**OBSERVATION/SUBMISSION TO PLANNING APPLICATION**

**Case Reference: 324113**

**Re: Observation to the proposed development of open-cycle gas turbine (OCGT) and generator with ancillary equipment.**

Applicant: Bord Gáis Energy Limited

Poster distribution locations in Athenry

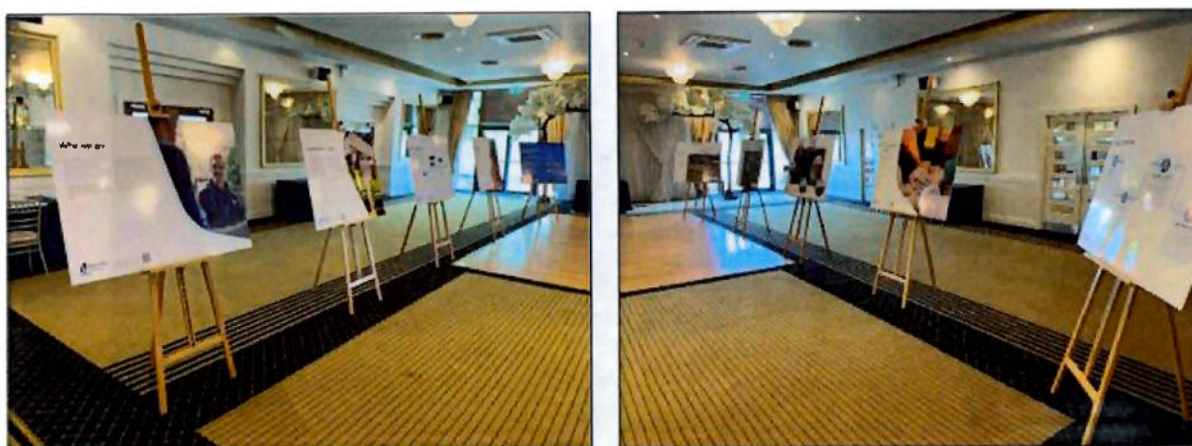
Furthermore, I did not receive any leaflet or information about the event prior. When I asked the liaising officer about this, it was explained they were let down by a 3<sup>rd</sup> party delivery company and apologised about this. At a meeting held with Bord Gais on the 16<sup>th</sup> of October 2025, we were informed that 25 A3 size posters that are referenced on Page 45 from the submission as show below were distributed by a 3<sup>rd</sup> party firm also. I never saw any of these posters, my family never saw any of these poster, I have asked close to 50 people if they saw these, and not one person I spoke to has ever seen these posters and it would be interesting to find out if these

were put up in the first place? Again, might be considered a small matter, but communication engagement has not been fulfilled.

When raising the question about community engagement (or lack off) at a meeting on the 16<sup>th</sup> of October, I was informed that everyone within a 2 km area deemed in the ‘‘affected area’’ received communication by form of a leaflets on communication about open events.
